STAFF RECOMMENDATION
3000 Belmont Boulevard
August 20, 2014

Application: New construction-addition & outbuilding
District: Belmont-Hillsboro Neighborhood Conservation Zoning Overlay
Council District: 18
Map and Parcel Number: 11708015000
Applicant: Steve Durden, Durden Architecture
Project Lead: Paul Hoffman, paul.hoffman@nashville.gov

<p>Description of Project: The applicant proposes a rear addition and outbuilding.</p> <p>Recommendation Summary: Staff recommends approval with the conditions that:</p> <ol style="list-style-type: none"> 1. Lap siding shall have a reveal no greater than five inches (5"); 2. Staff approve the materials for construction of the outbuilding stairs; 3. Staff approve the final details, dimensions and materials of windows and doors prior to purchase and installation; and, 4. Staff approve the roof color and a masonry sample for dimensions and texture; 5. That four inch (4") wood casings be used around doors, windows and vents; and, 6. HVAC and other utilities shall be located to minimize visibility from the street, if they are to be moved. <p>Staff finds that the project meets II.B of the <i>Belmont-Hillsboro Neighborhood Conservation District: Handbook

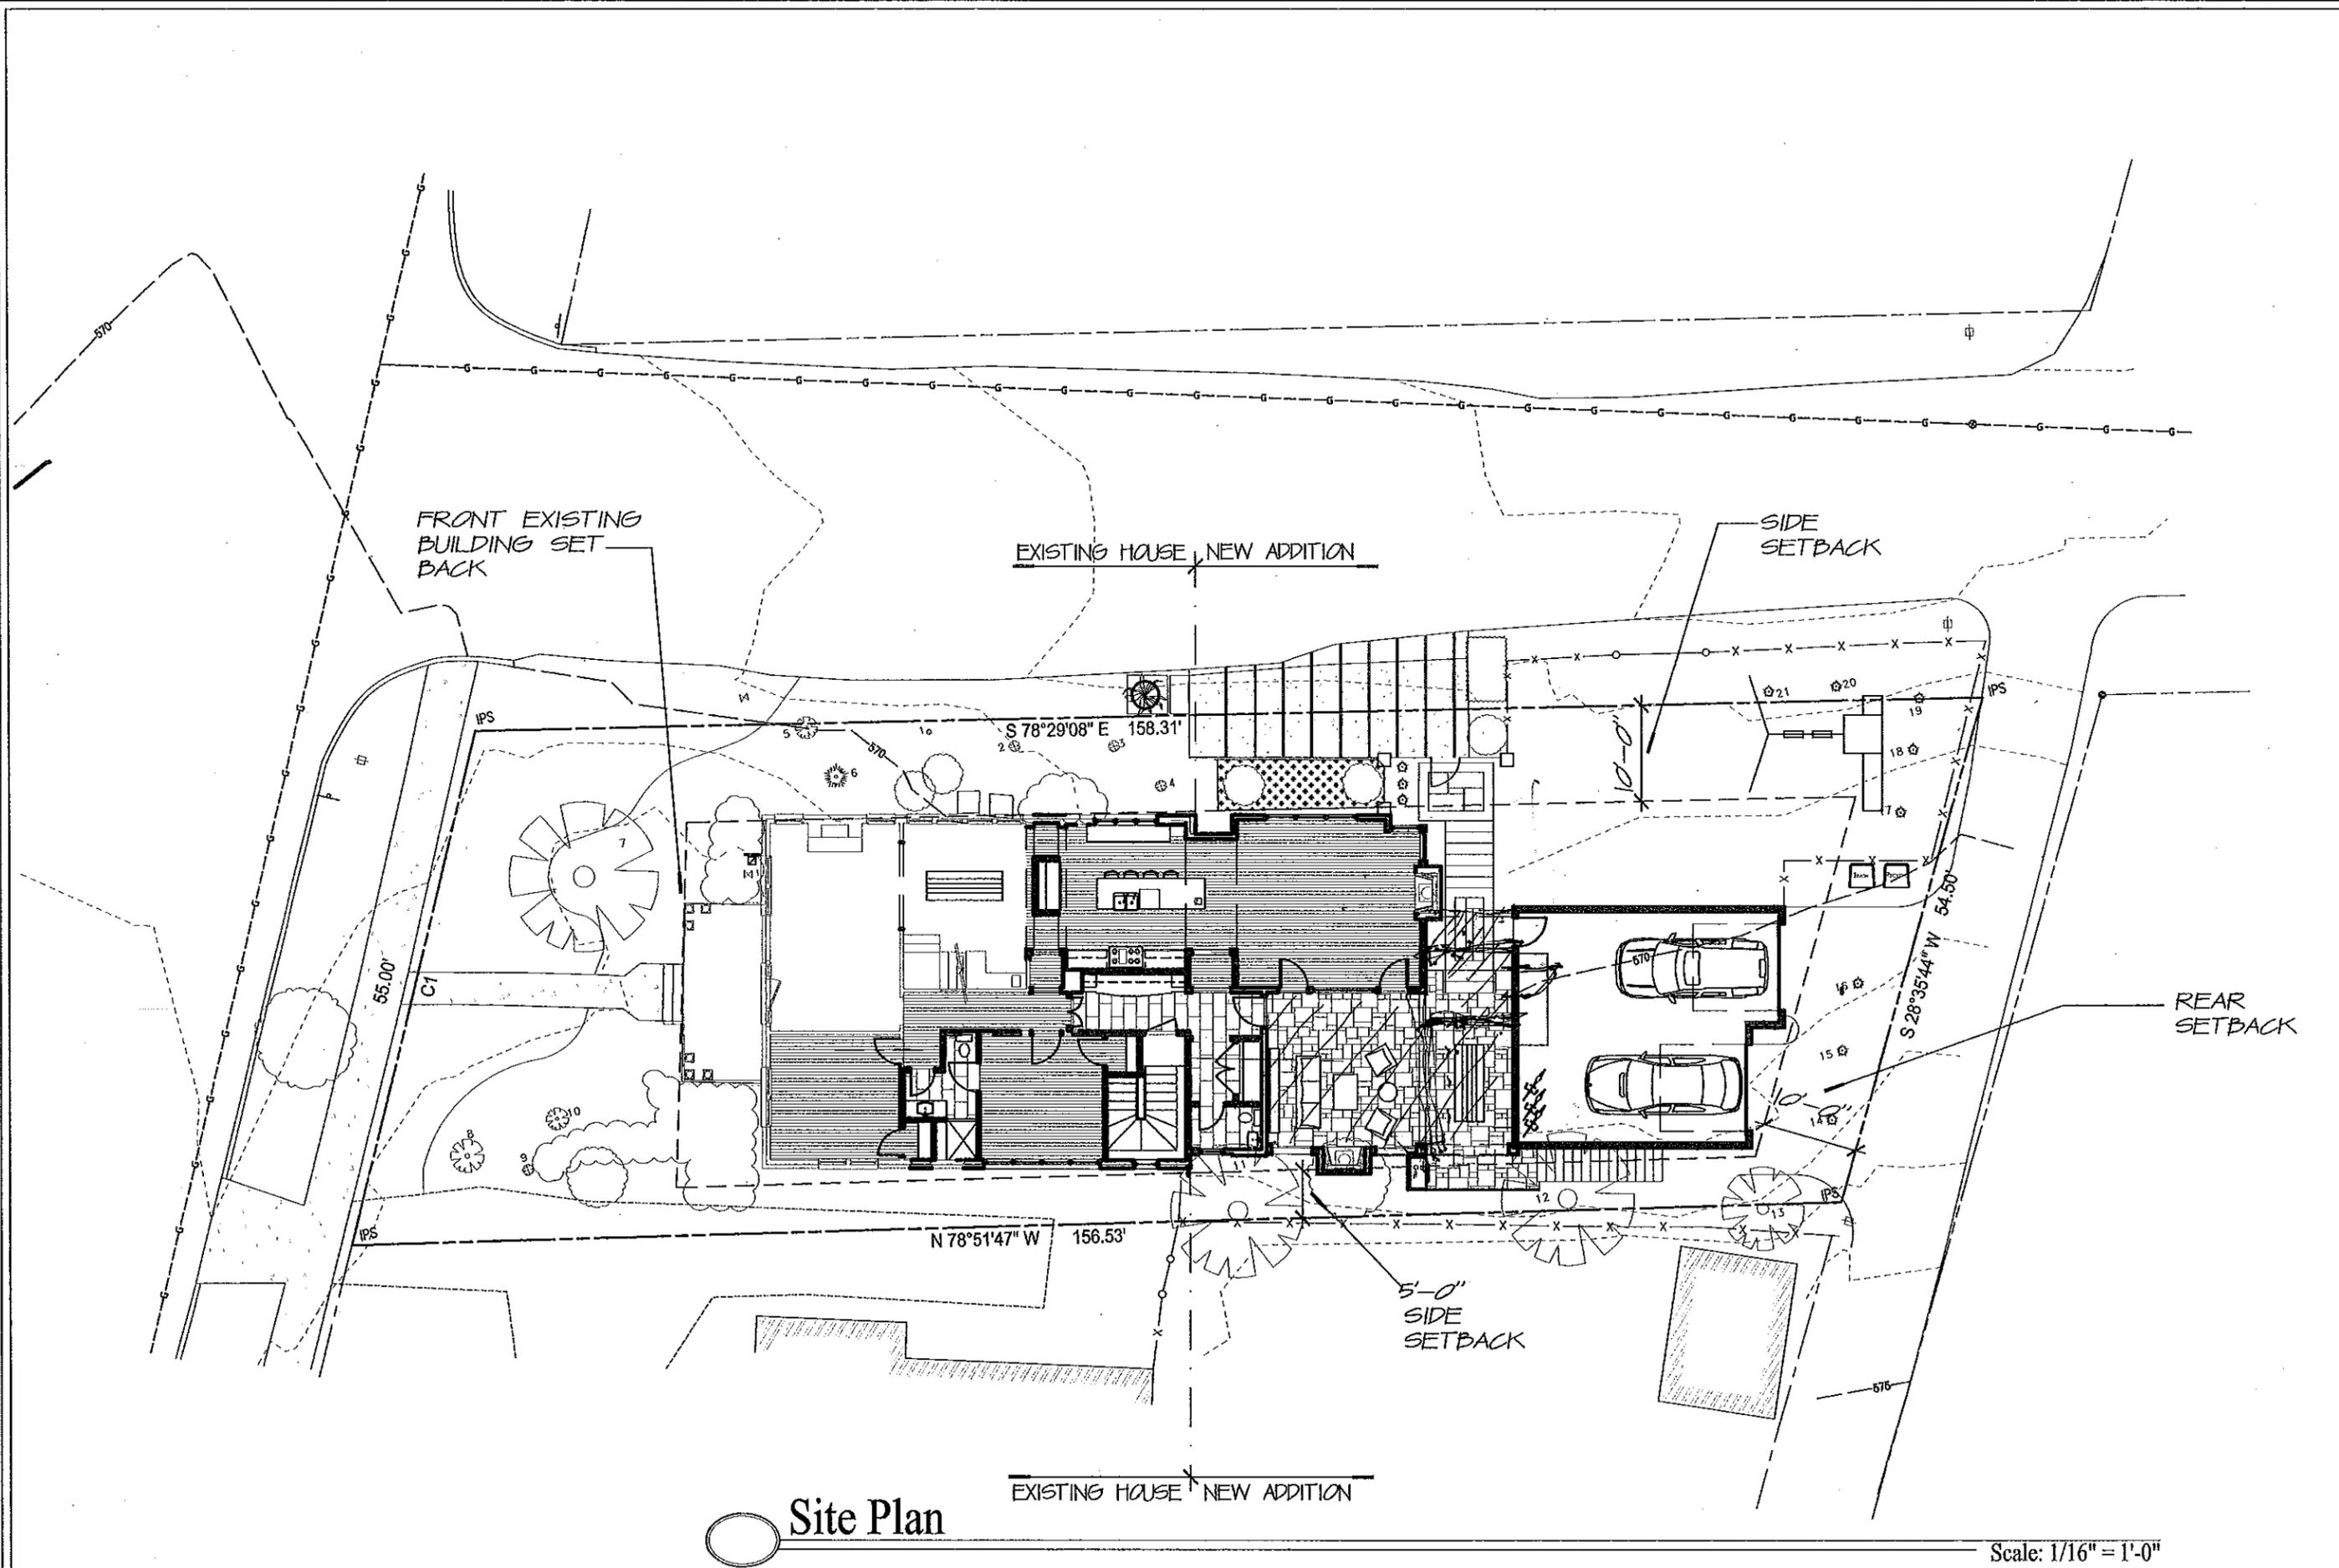
Roofing will be architectural shingles in a color to match the house. The first story will be brick painted to match the house. Staff asks to approve a sample of the brick. The upper story will be cement fiber siding. Siding reveal will match that of the house, with a maximum reveal of five inches (5"). Materials for the exterior stairs were not provided; staff requests final approval of those materials prior to construction. Staff requests final approval of windows and doors as with those previously mentioned in the project.

The proposed outbuilding is compatible with the house and existing outbuildings. With approval of a brick sample for dimension and texture, as well as the windows and doors, and material for the stairs, the project meets section II.B.1.i of the design guidelines.

1. Siding shall have a reveal no greater than five inches (5");
2. Staff approve the materials for construction of the outbuilding stairs;
3. Staff approve final details, dimensions and materials of windows and doors prior to purchase and installation;
4. Staff approve the roof color and all masonry samples for dimensions and texture;
5. That four inch (4") wood casings be used around doors, windows and vents; and,
6. If the HVAC unit or other utilities are moved, they shall be located to minimize visibility from the street.

○ Site Plan

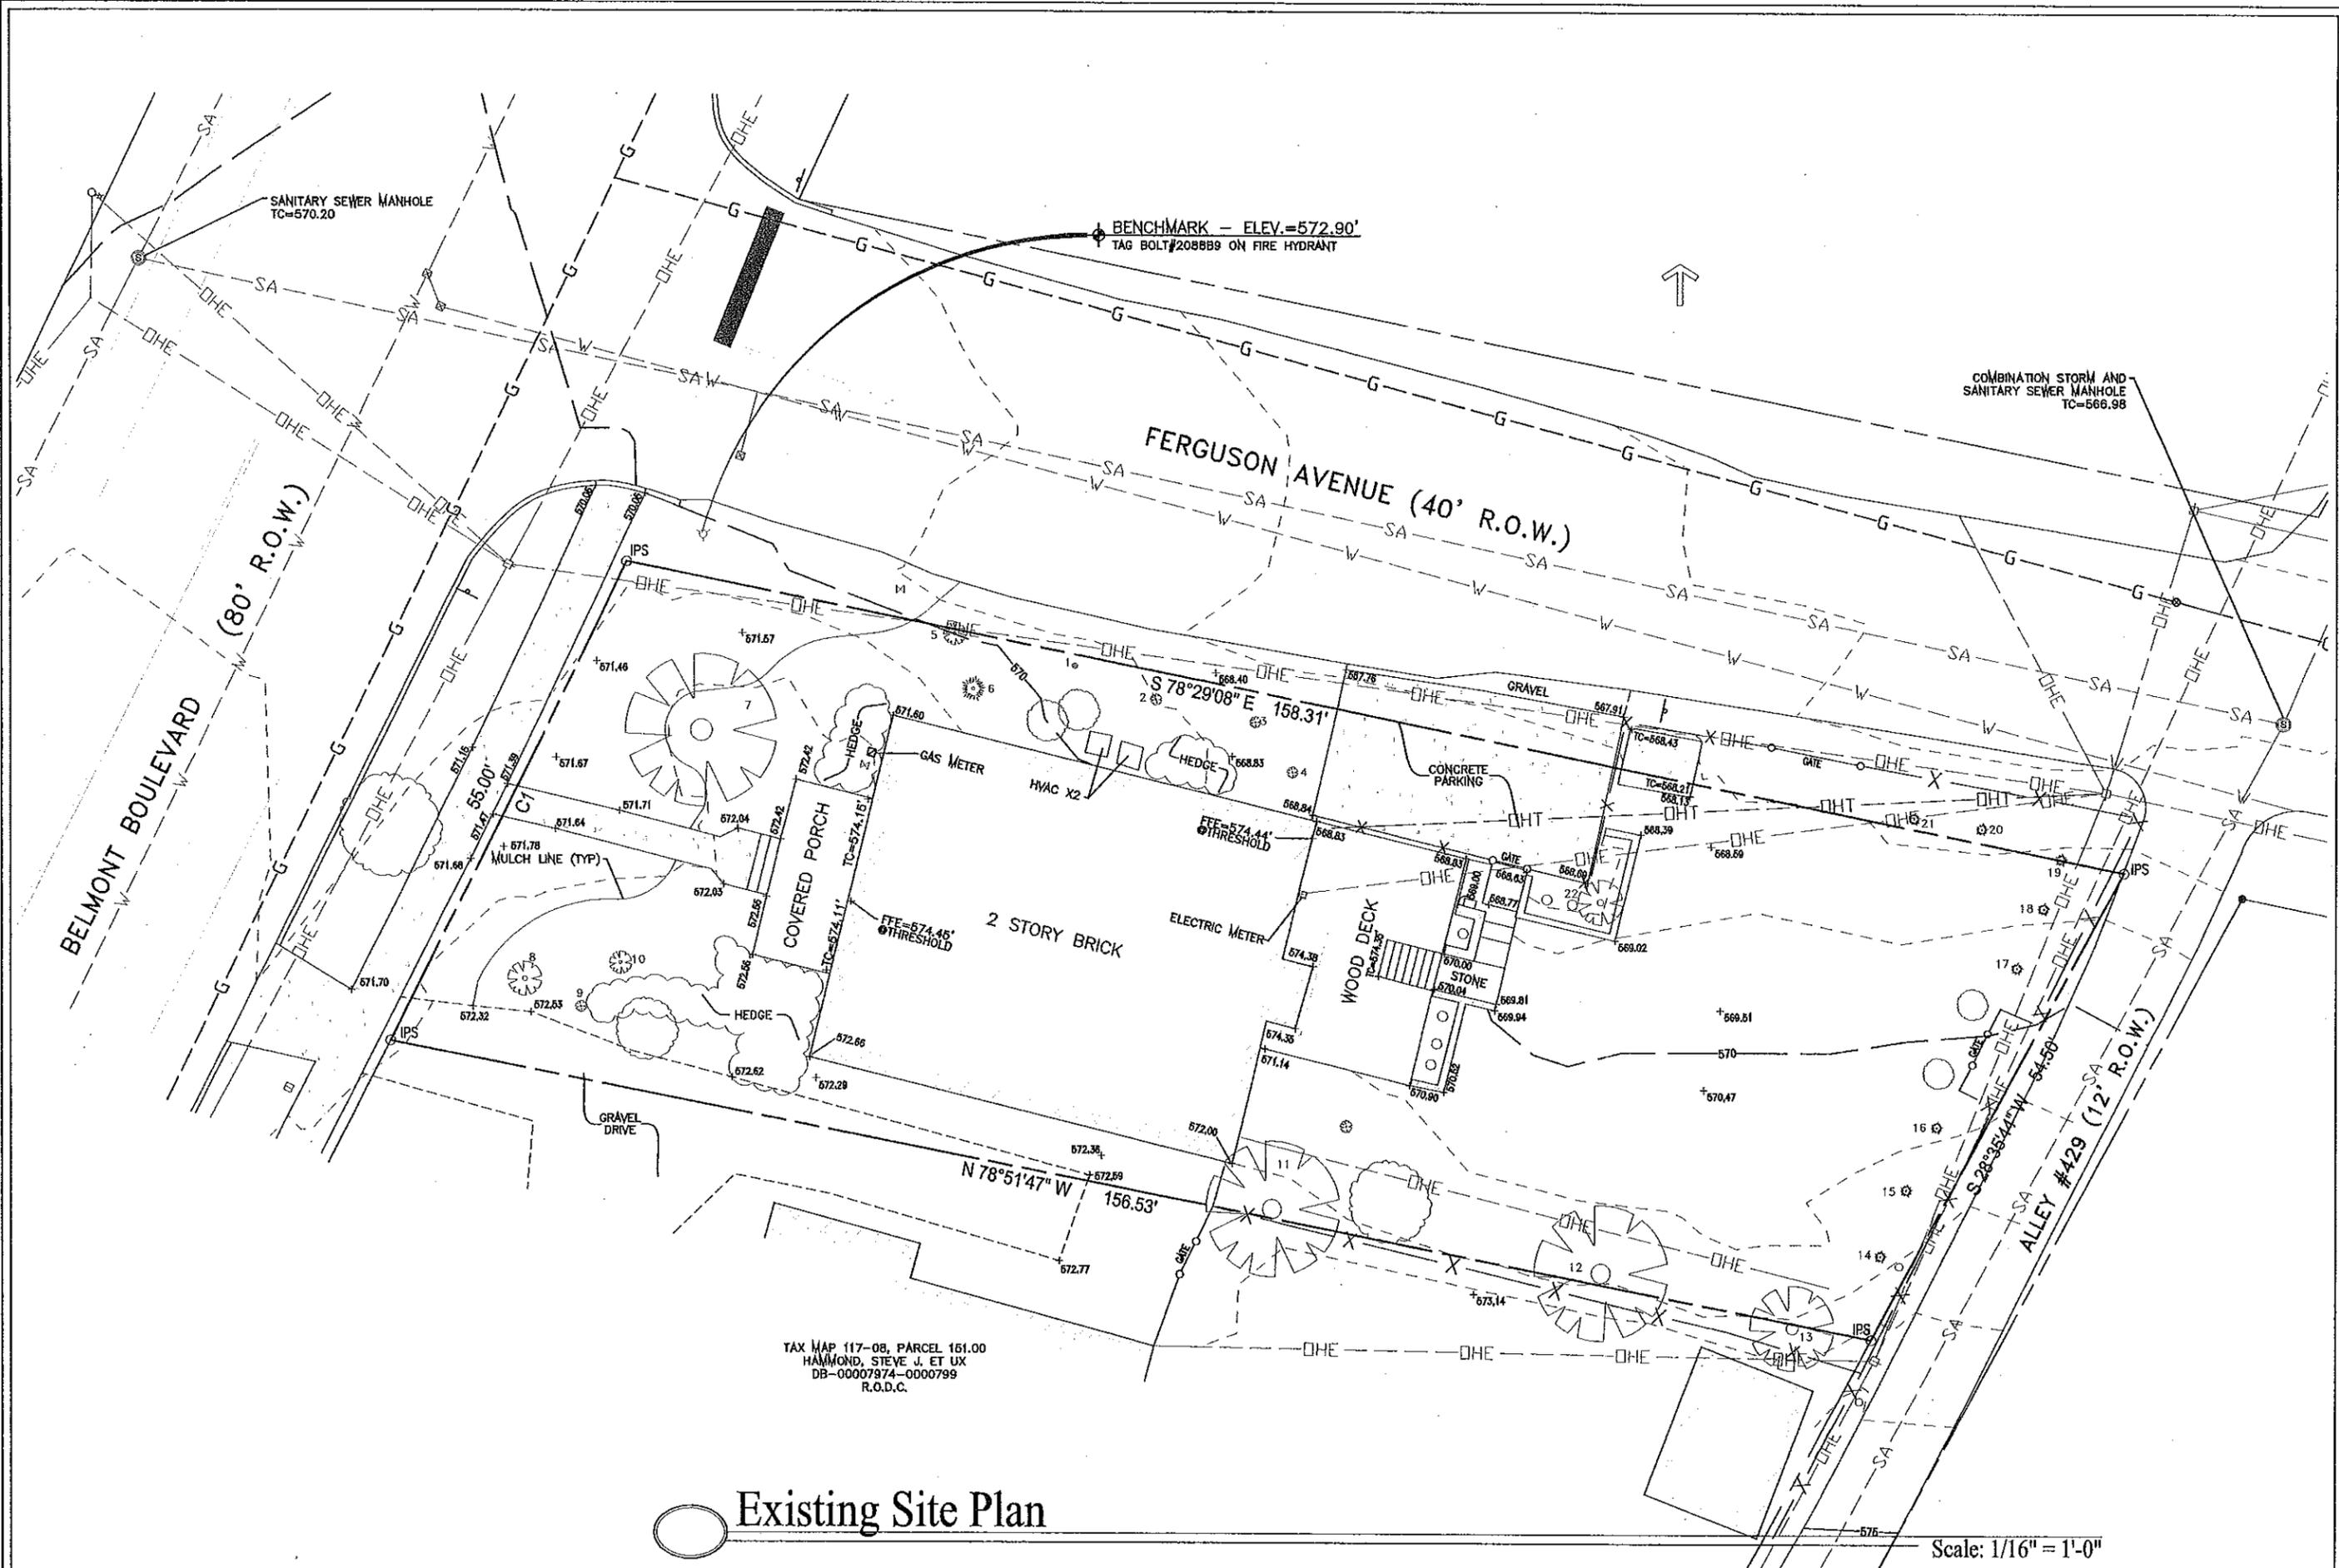
Setback & Rhythm of Spacing: The building is located at the corner of Belmont and Ferguson Avenue. The sides of the addition will be ten feet (10') from the left side, along Ferguson Street and approximately seven feet (7') from the right side, It will be approximately forty-five feet (45') at its closest to the rear property line. The addition meets base setback requirements of five feet (5') on the sides and twenty feet (20') at the rear. According to the site plan, the proposed chimney on the right side projects into the required setback by less than one foot (1'). A chimney that projects no more than three feet (3') into the setback is a permitted setback obstruction according to 17.12.040.E of the bulk regulations. The project meets section II.B.1.c.

Outbuildings: The location of the outbuilding at the rear of the lot is appropriate for outbuildings historically. Its design reflects the roof pitch and materials of the historic house.
